ORDINANCE NO. 25-4485

ORDINANCE APPROVING CERTIFICATE OF APPROPRIATENESS
RE: ARC 24-16 FOR THE PROEPRTY LOCATED AT 631 S. GROVE AVENUE,
BARRINGTON, ILLINOIS

CERTIFICATE OF APPROPRIATENESS

ARC 24-16: 631 S. Grove Avenue – HISTORIC/CONTRIBUTING

ELEVATION

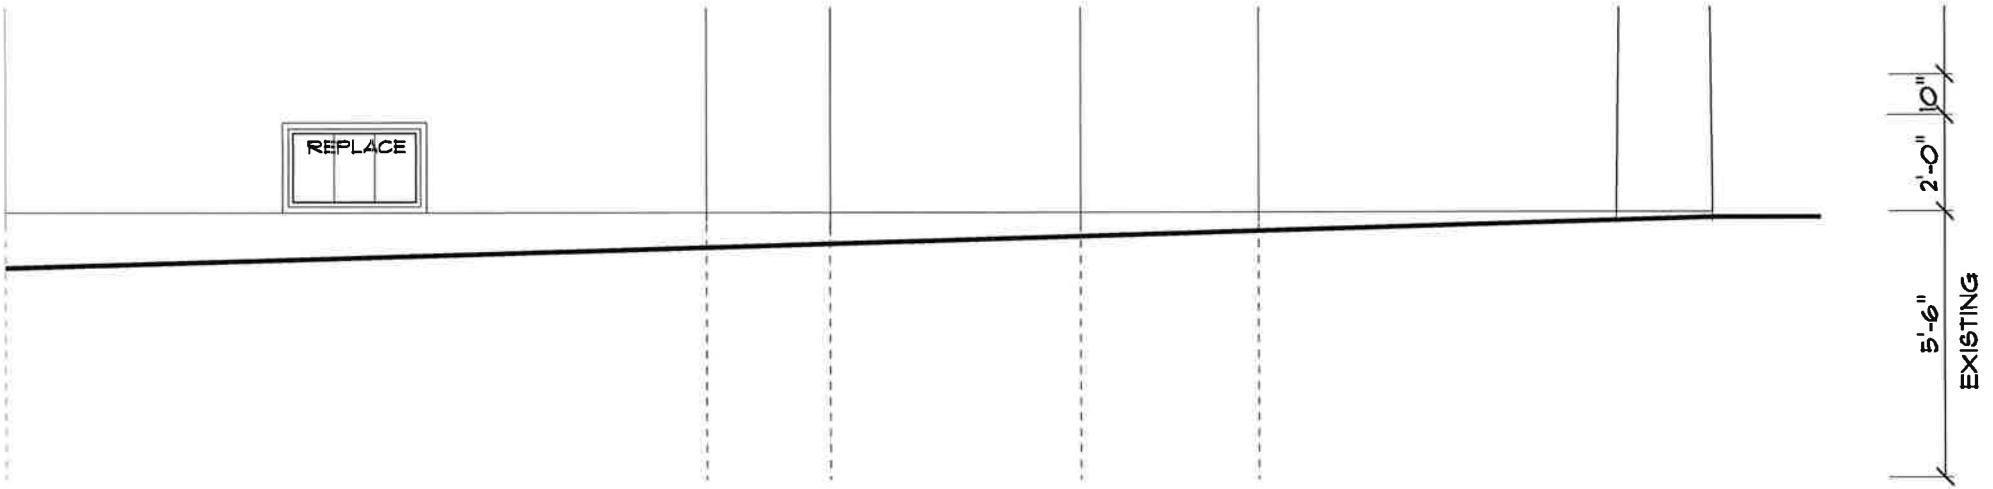
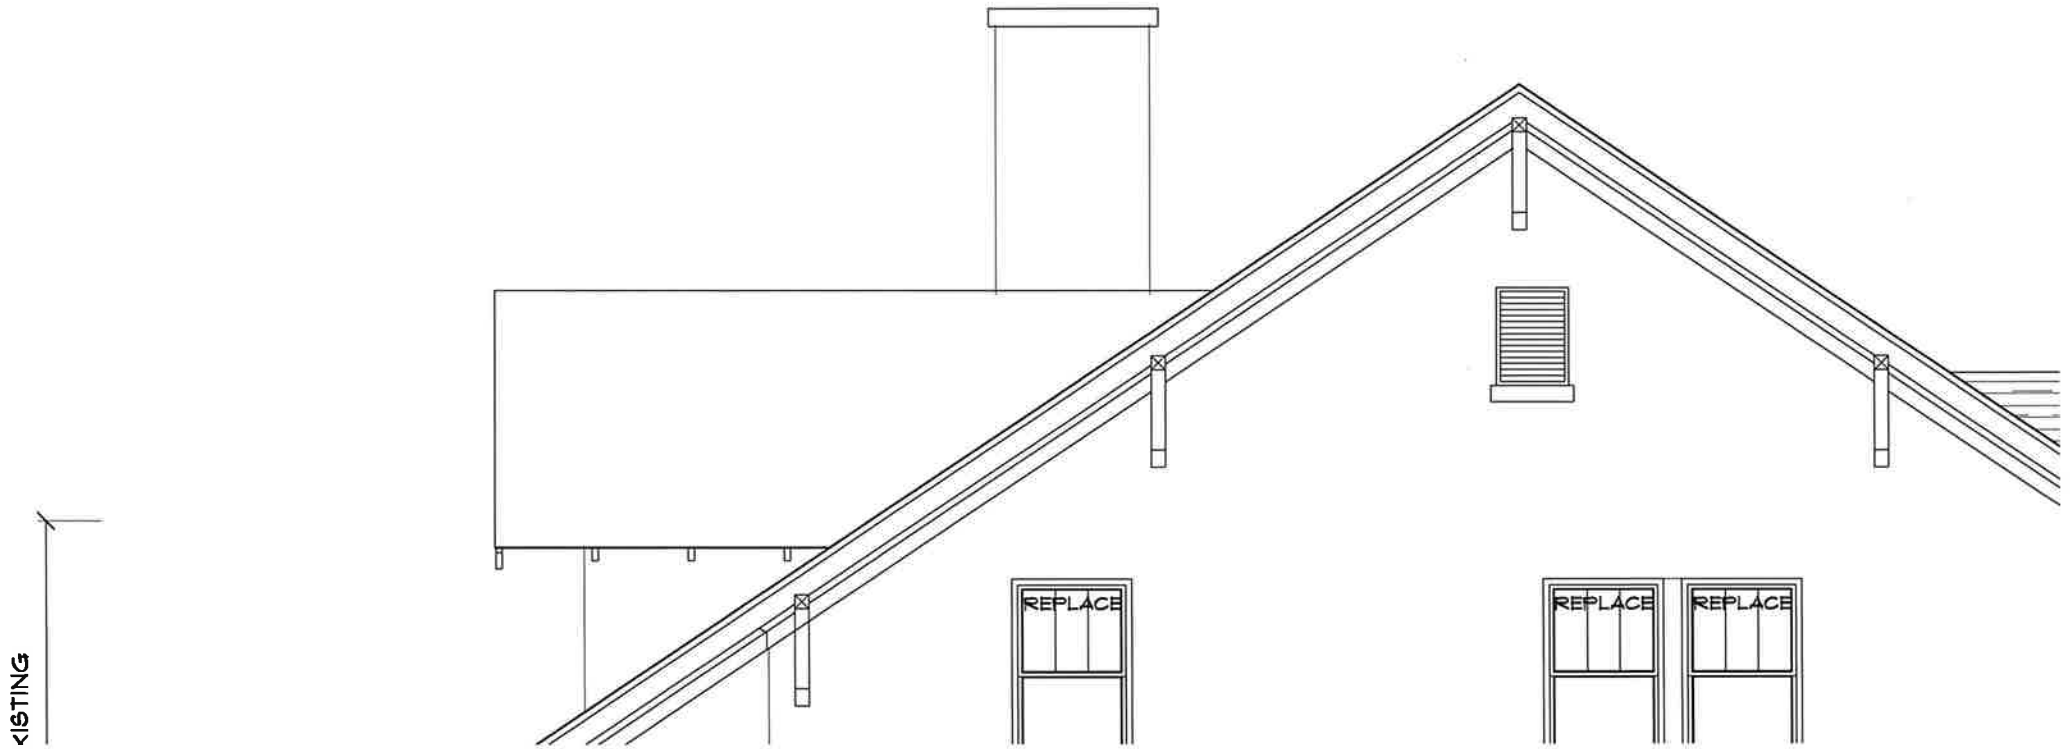
1. The ARC recommends that the brick base is brought in line with the wall plane.
2. Window and door casing must be added to all windows and doors on the proposed addition.
3. Window and door specifications must be provided at the time of permit. Selections must be fully compliant with all Historic District regulations.
4. An ARC Inspection will be a requirement of the building permit for the Project.
5. All plans are subject to final building, engineering and zoning review prior to the issuance of a building permit. Modifications to the approved plans may require additional review by the Architectural Review Commission.
6. All conditions stated above must be addressed in the construction drawings submitted for building permit.

7. The ARC recommends that the brick base is brought in line with the wall plane.
8. Window and door casing must be added to all windows and doors on the proposed addition.
9. Window and door specifications must be provided at the time of permit. Selections must be fully compliant with all Historic District regulations.
10. An ARC Inspection will be a requirement of the building permit for the Project.
11. All plans are subject to final building, engineering and zoning review prior to the issuance of a building permit. Modifications to the approved plans may require additional review by the Architectural Review Commission.
12. All conditions stated above must be addressed in the construction drawings submitted for building permit.
